Air Quality - Response to Havant Borough Council Environmental Health Additional Comments

32 New Lane, Havant, Hampshire

Issued: 18th August 2021

Delta-Simons Project Number: 20-1275.03

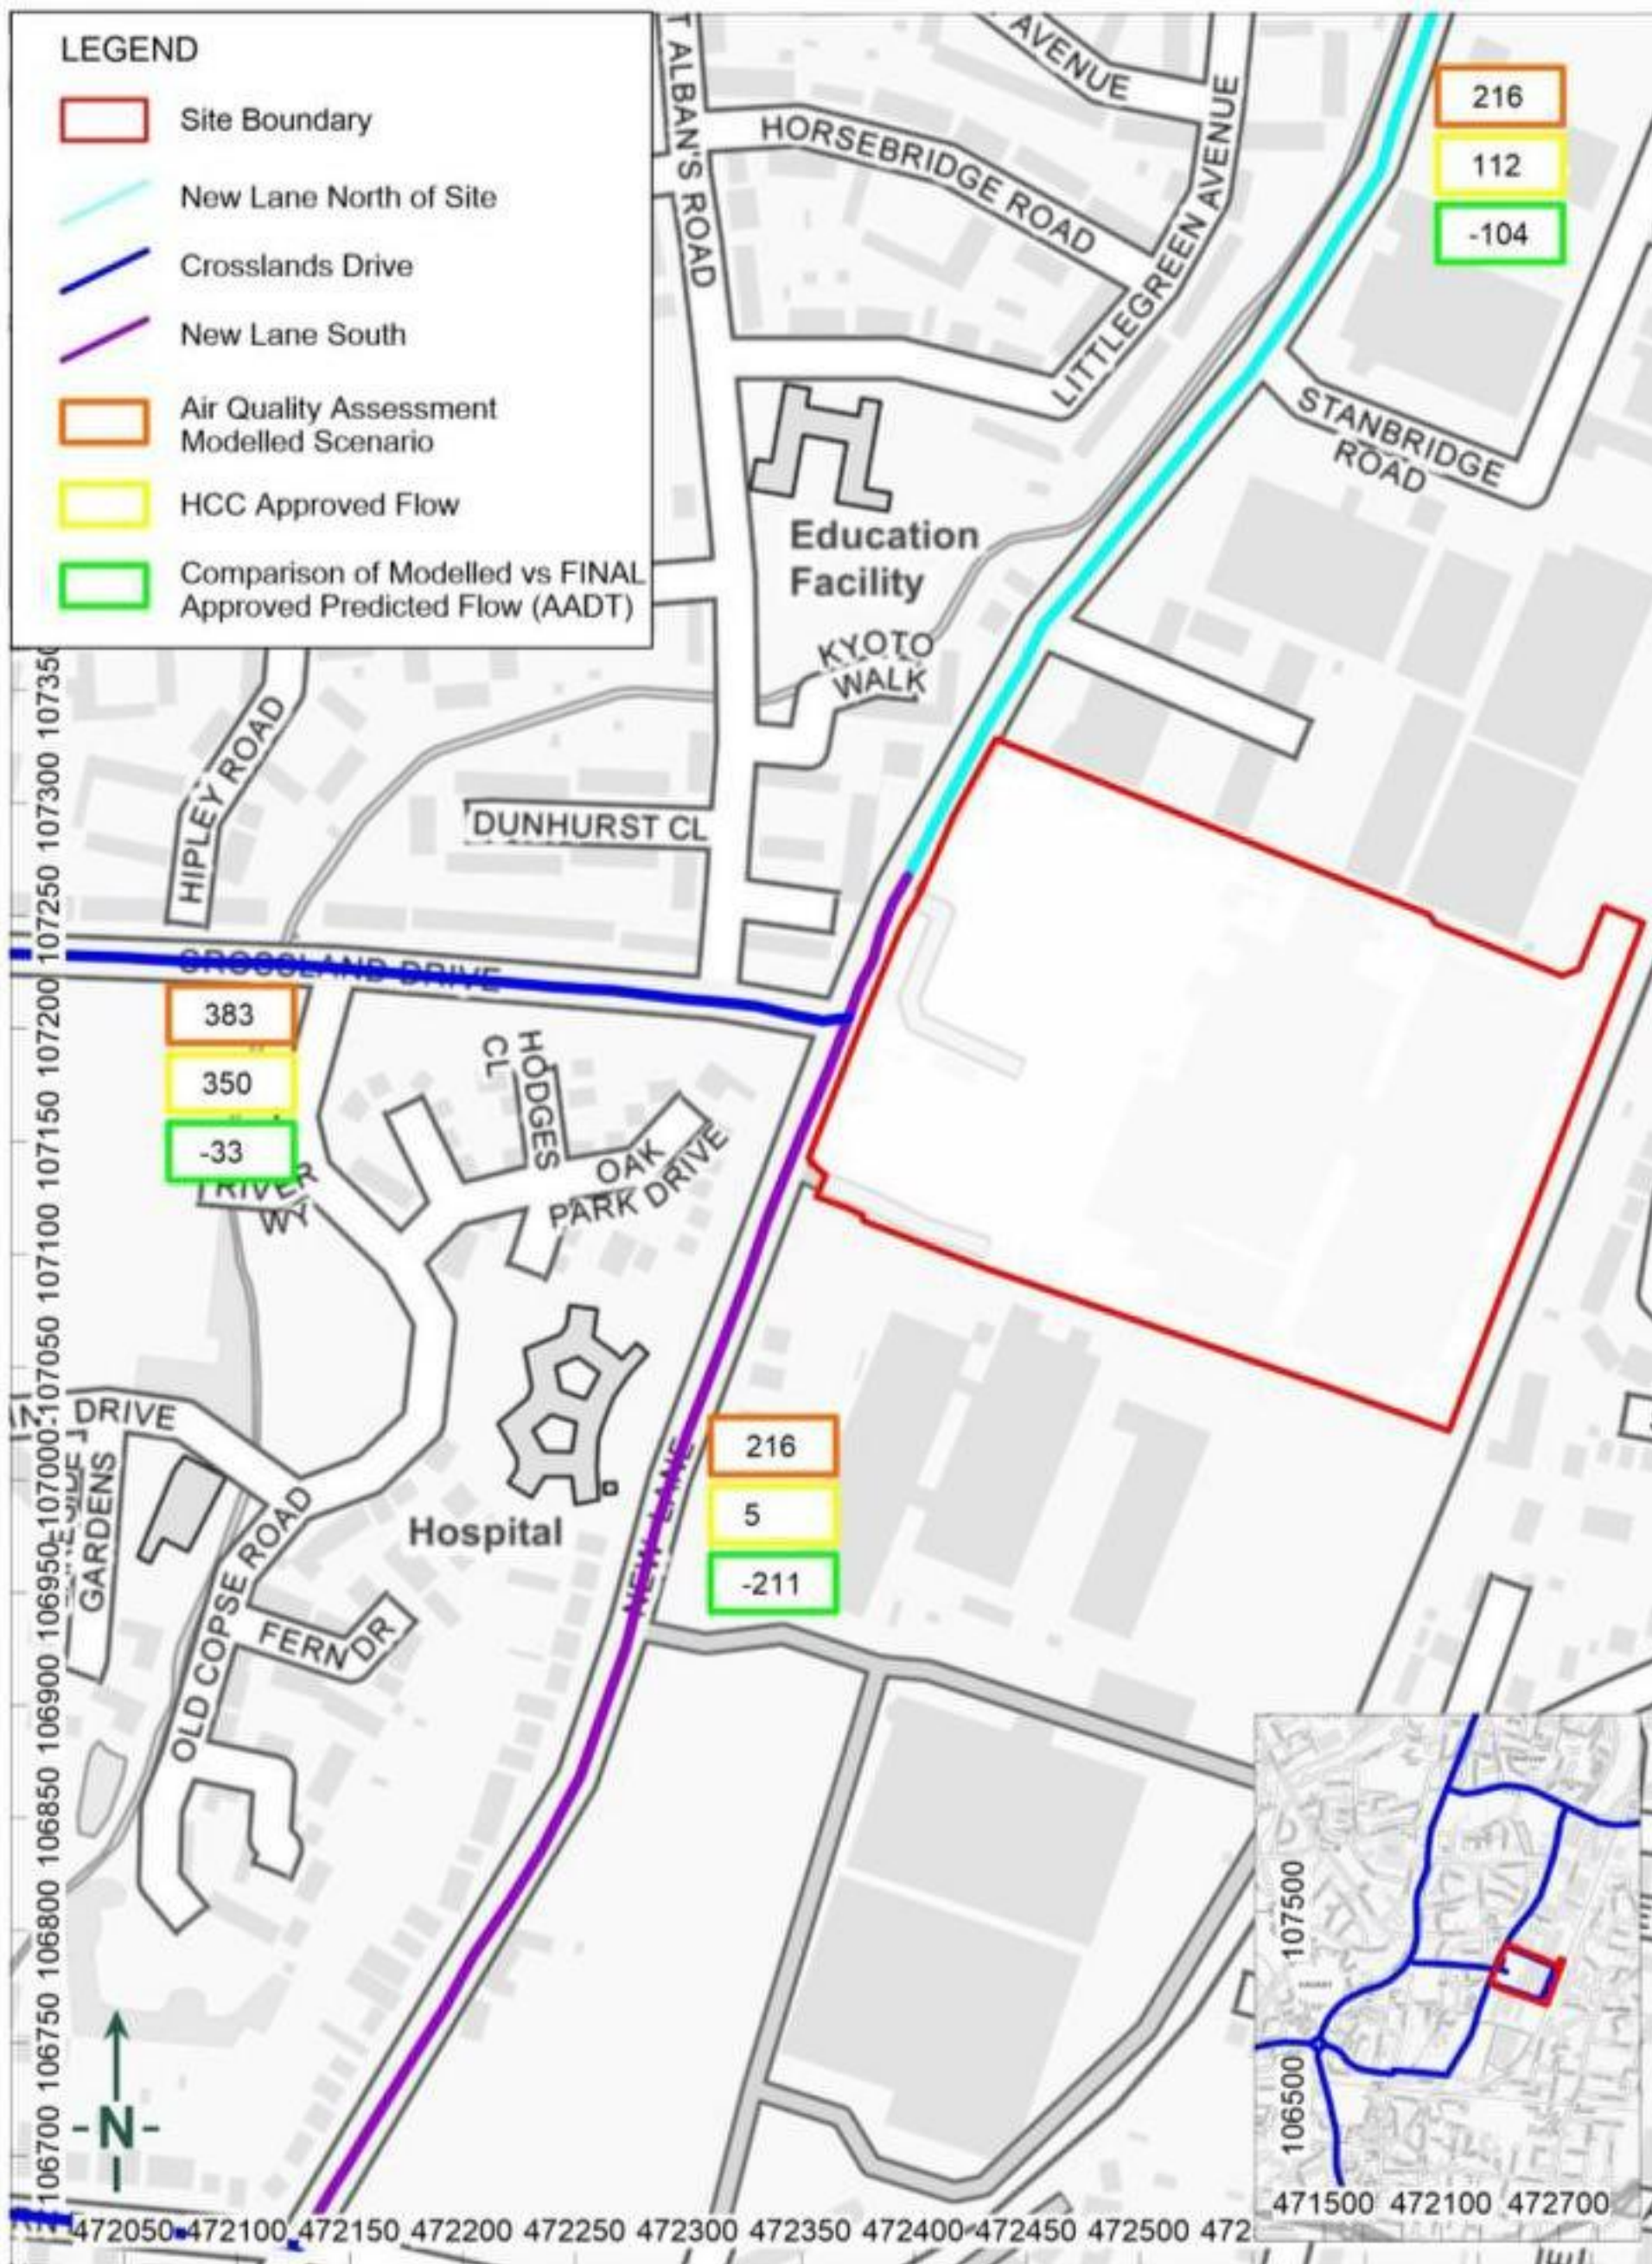
The response to Comment 4 serves to demonstrate the 'fluidity' of estimates of transport demand which I have previously referred to, highlighting that the most recent demand estimates (presented in the supplementary Transport Assessment) amount to a net increase in transport demand from the site of reduced magnitude to that included within the Delta Simons Air Quality report. At the time of writing, the Highways Authority was understood to remain unsatisfied with the estimates of net change relative to the extant site (in it's wound-down state, i.e. the real world impact), and I had for this reason intended to reiterate comments made previously. However, the applicant has today forwarded further comments from the Highway Authority, which I have now reviewed. This response is amended to reflect those comments.

It is understood that the Highways Agency has now agreed a degree of 'netting' of traffic for the purpose of junction capacity modelling. Whilst it is implicit from the Highways Agency response that it has agreed figures for 'traffic net-change', the net change in AADT transport demand associated with the site is not specified within the consultation response, and is not specified in either the Supplementary- or Addendum- Transport Assessment.

The purpose of the air quality assessment is to estimate the net change in air quality as a result of the development – the 'net change in transport demand associated with the development land' must be known / agreed to be reasonable. It appears that the gross demand of ~/<2500 AADT is agreed, however I remain unclear as to whether the final agreed net change estimate is significantly greater than the value assumed within the Delta Simons Air Quality Report (or not).

The final distribution, as agreed with HCC, is amended slightly from that presented in the JTN, however, the development generated traffic flow on each road link is still expected to be lower than those included in the dispersion model for the DS report. For completeness and to allow comparability, the final net development flows are presented in the following table alongside those used for the dispersion model.

Road	Air Quality Assessment Modelled Scenario	HCC Approved Flow	Comparison of Modelled vs FINAL Approved Predicted Flow (AADT)
	AADT increase due to development	AADT increase due to development	
New Lane North of Site	216	112	-104
Crosslands Drive	383	350	-33
New Lane South	216	5	-211

In order to represent a robust assessment approach, as indicated above, the Dispersion Modelling Assessment undertaken as part of Air Quality Assessment considered that there would be 216 AADT on New Lane both north and south of the Site. This was a robust assumption made for the purposes of the assessment which would not occur in reality as the traffic would not be able to travel both ways on New Lane. Reference should be made to **Figure 1** for a Layout Plan of Modelled Road Links and Associated Traffic Flows.

The predicted traffic flows generated by the Proposed Development, as agreed with HCC, are lower on all road links (as per the last column of the above table) resulting in a robust assessment approach and, therefore the impacts on pollutant concentrations would be also lower than those presented in the DS Report. As such, the impact of the Proposed Development on concentrations of nitrogen dioxide (NO₂) and particulate matter (PM₁₀ and PM_{2.5}) would remain **negligible**, with the resulting effect considered to be **not significant** accordingly.
